**BROWNS FERRY NUCLEAR PLANT (BFN) - UNITS 1, 2, AND 3 -
TECHNICAL SPECIFICATIONS (TS) CHANGES TS-431 AND TS-418 -
EXTENDED POWER UPRATE (EPU) - RESPONSE TO ROUND 6 REQUESTS
FOR ADDITIONAL INFORMATION (TAC NOS. MC3812, MC3743, AND
MC3744)**

**TECHNICAL SPECIFICATIONS (TS) CHANGES TS-431 AND TS-418 -
EXTENDED POWER UPRATE (EPU) - RESPONSE TO ROUND 6 REQUEST FOR
ADDITIONAL INFORMATION (TAC NOS. MC3812, MC3743, AND MC3744)**

RESPONSES TO REQUESTS FOR ADDITIONAL INFORMATION

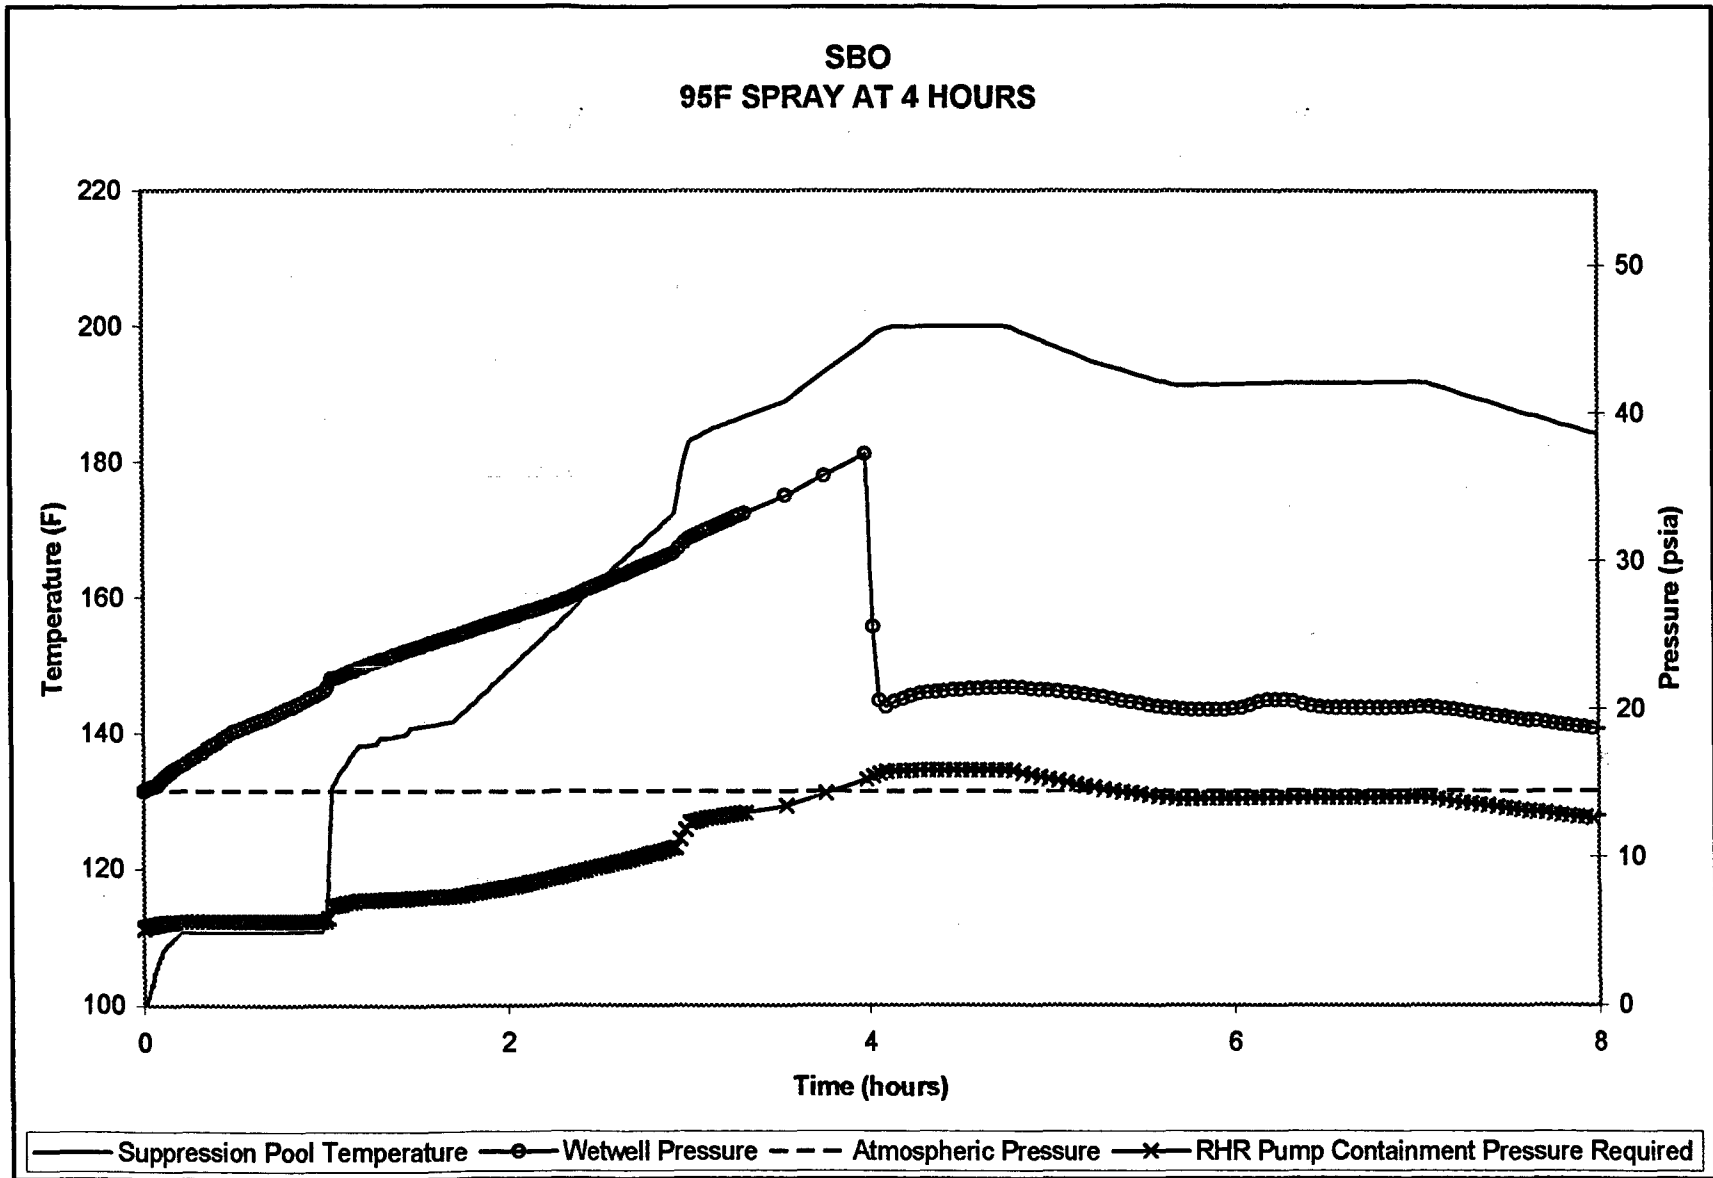
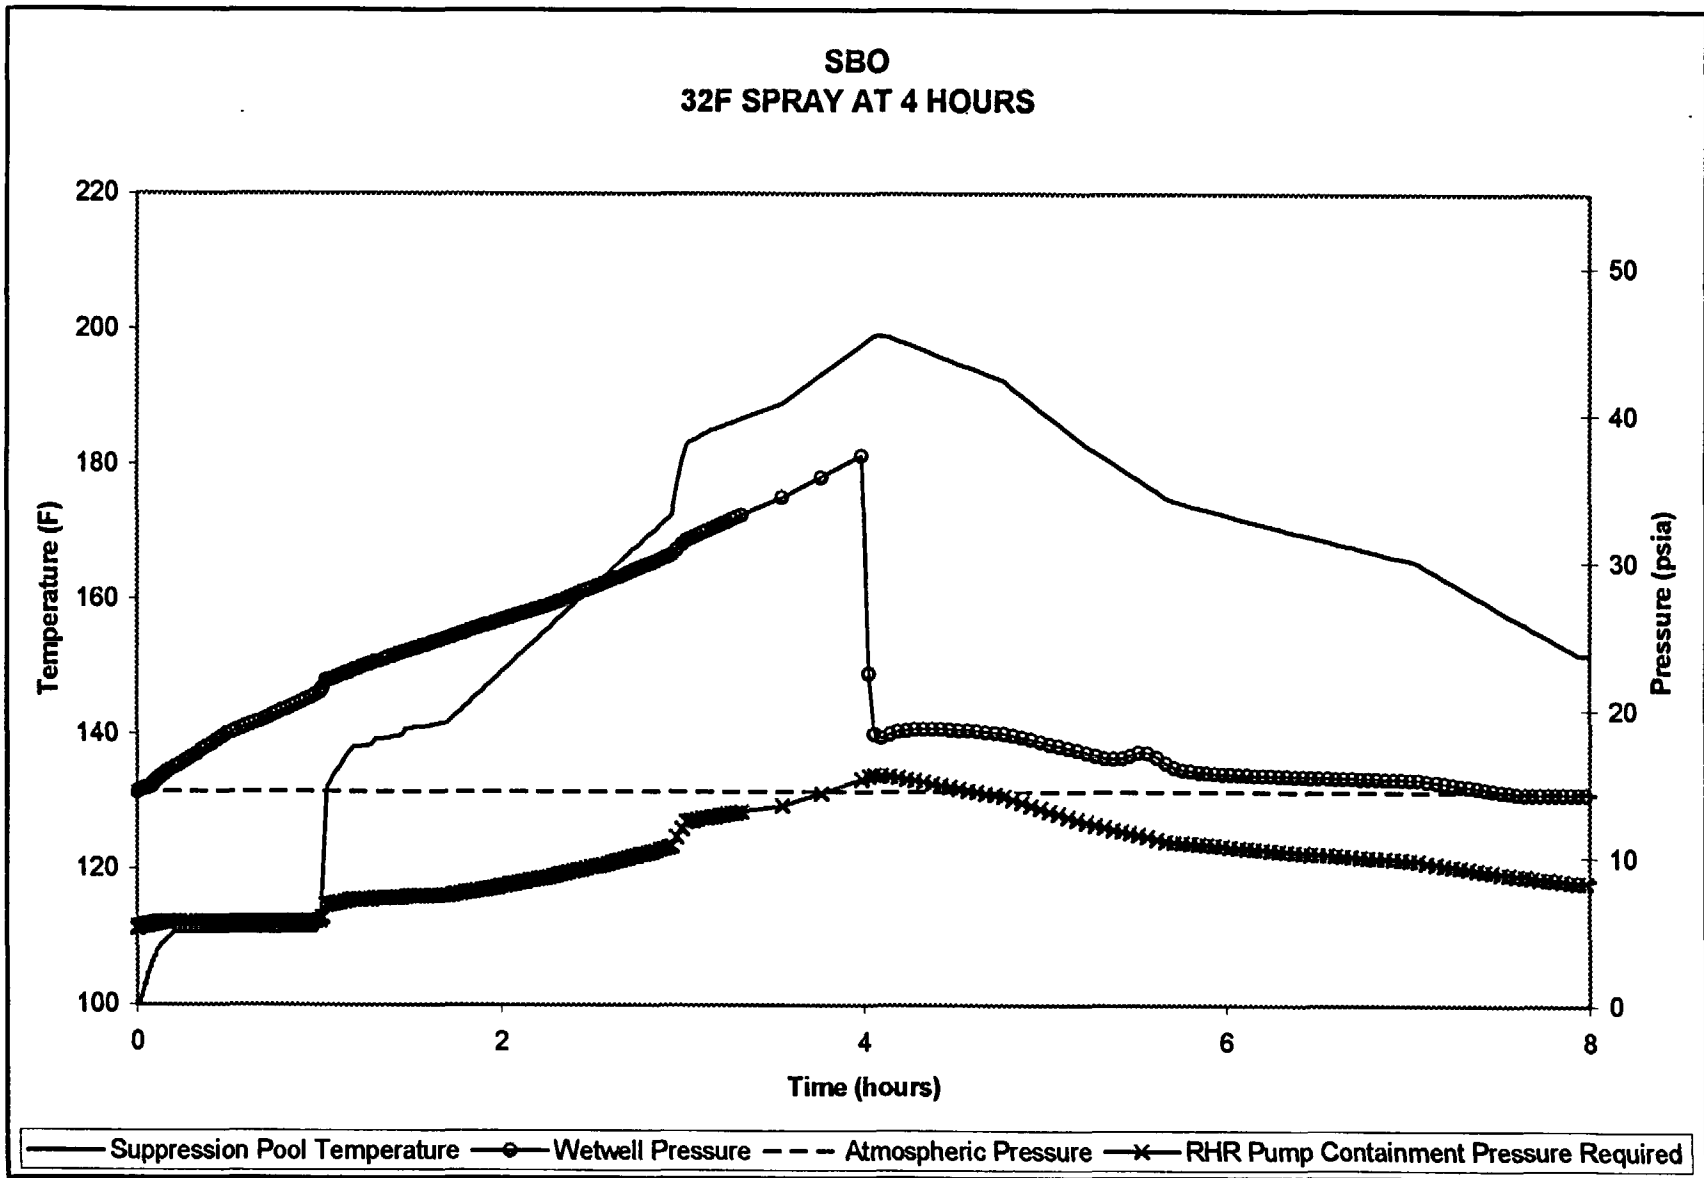
The response to RAI ACVB 18 provided curves of pressures and temperatures for the events crediting containment accident pressure for available NPSH. The curves for ATWS and Appendix R Fire should be extended to provide the total time that containment accident pressure is needed for available NPSH.

For the SBO analysis, it is assumed that containment spray is initiated at the end of the 4 hour coping period when AC power is assumed to become available. Figures ACVB.56/54-5 and ACVB.56/54-6 show the results of the SBO event with containment spray included.

For the SBO event, assuming that containment spray is initiated at 4 hours when AC power is assumed to be restored, colder service water produced the smallest NPSH margin but significantly reduces the time period for which COP is required. Credit for COP will be based on the 95°F temperature assumption. Figures ACVB.56/54-5 and ACVB.56/54-6 show results for both cases.
